ORIGINATION FORM

Proposed Revisions to a Standard Plans Index

Index Number: 102-607

Index Title:
Mobile Operations

Sheet Number (s): 1 of 2

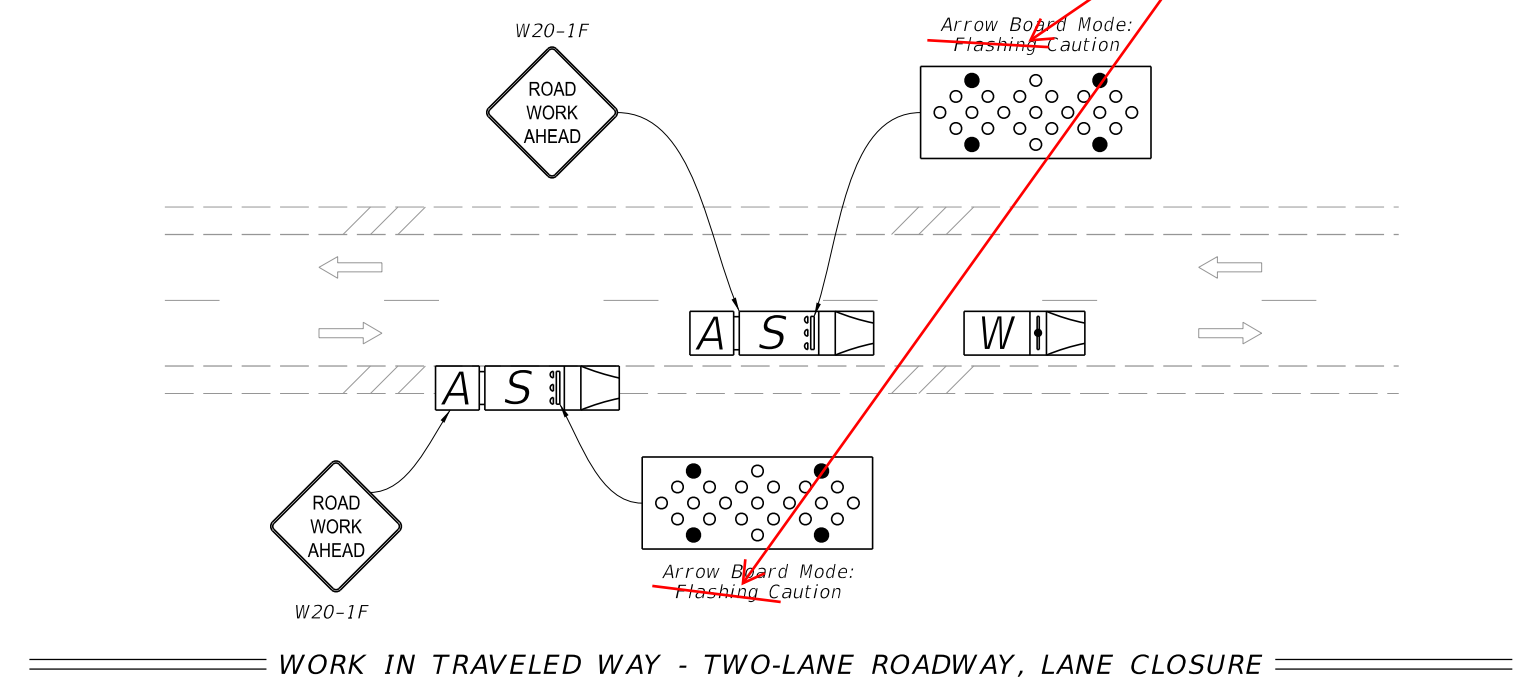
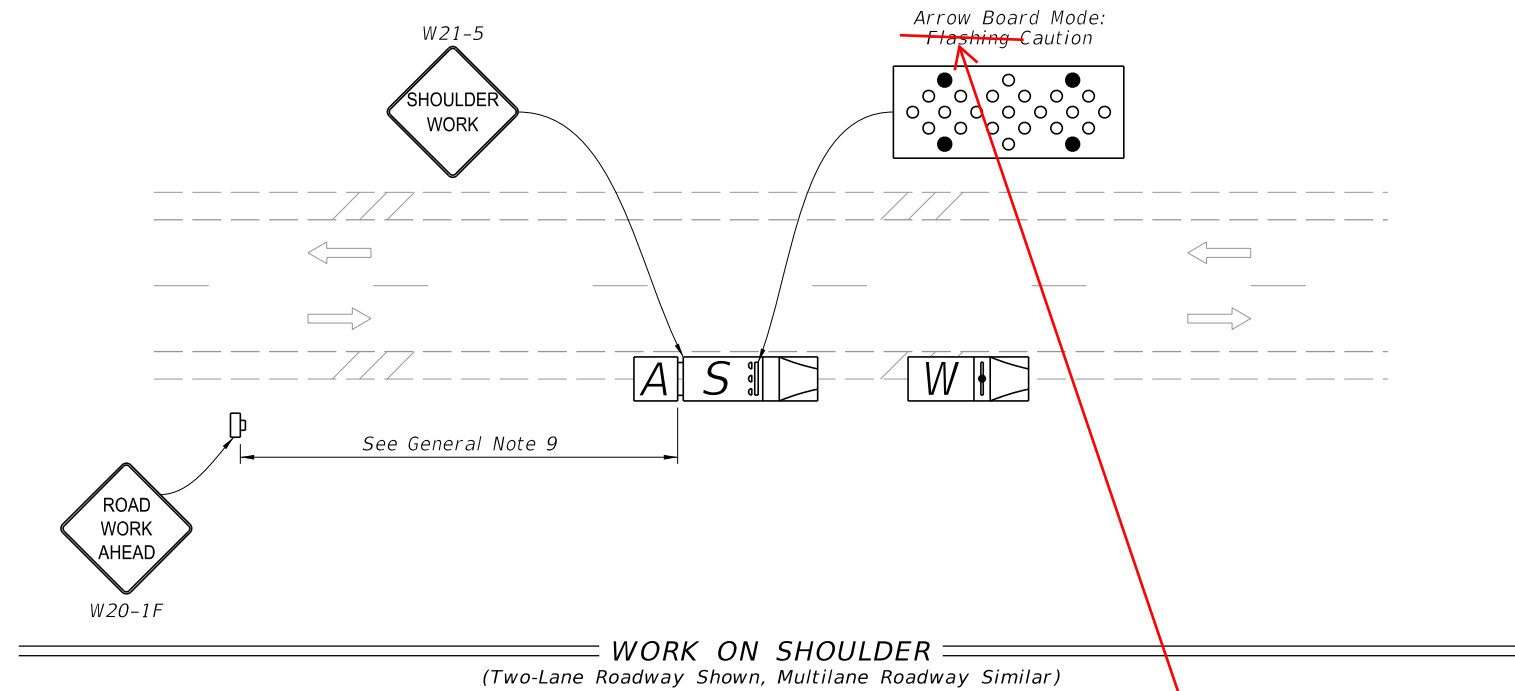
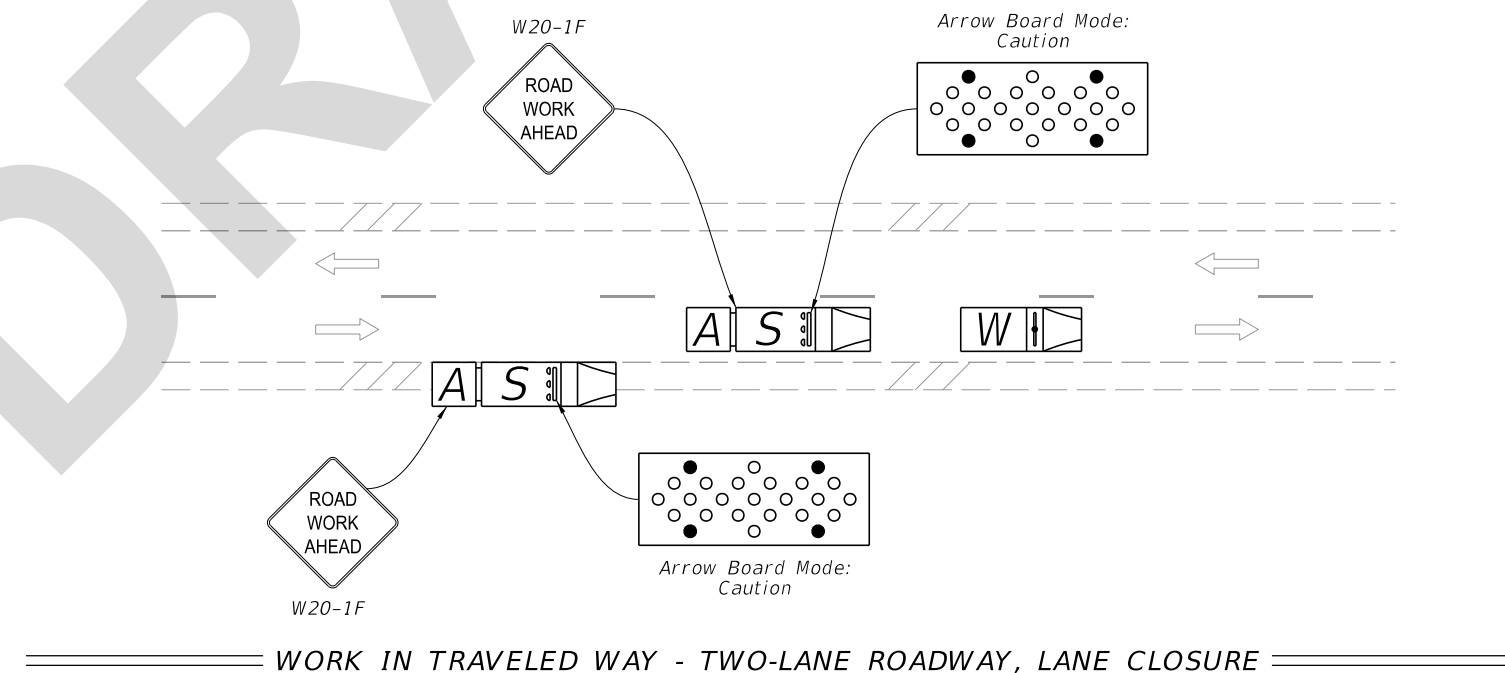
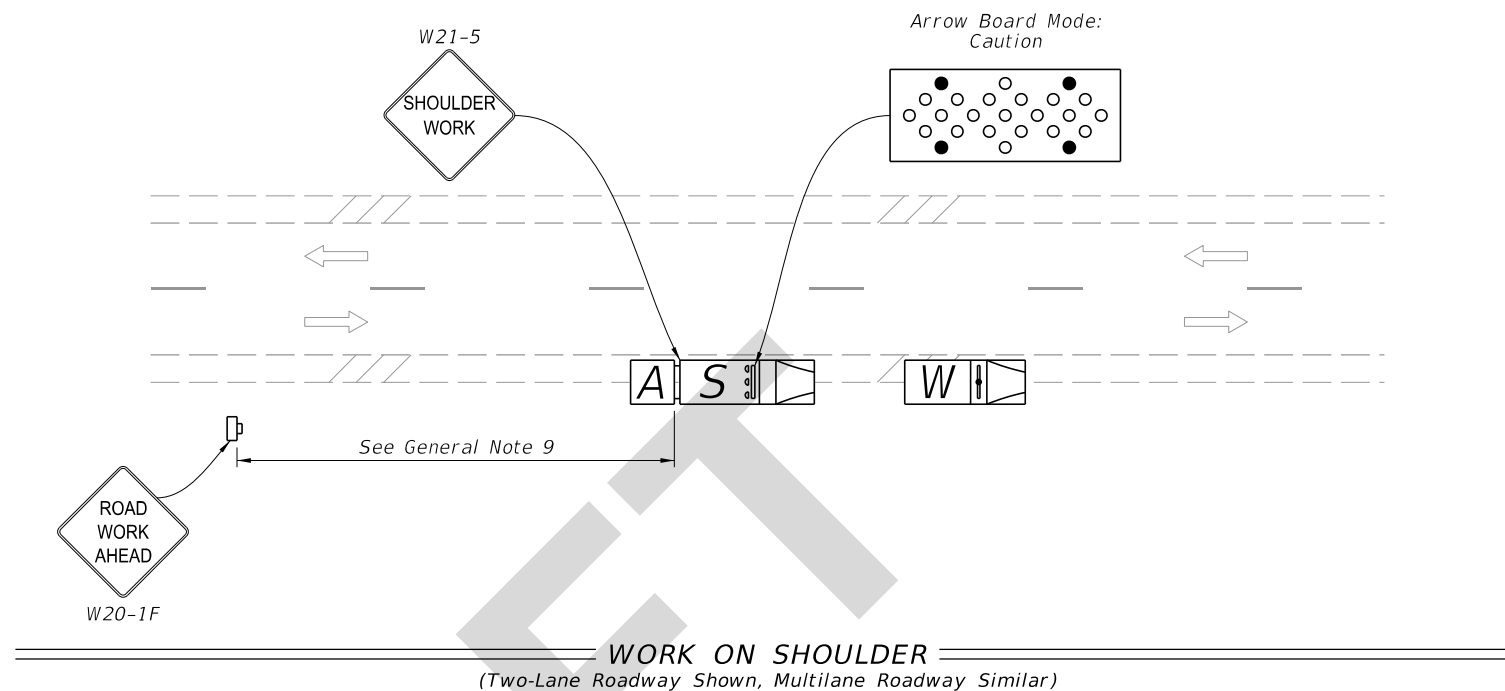
Sheet 1: Deleted "Flashing" from the Arrow Board Mode

General cleanup of the Index to make consistent with series.
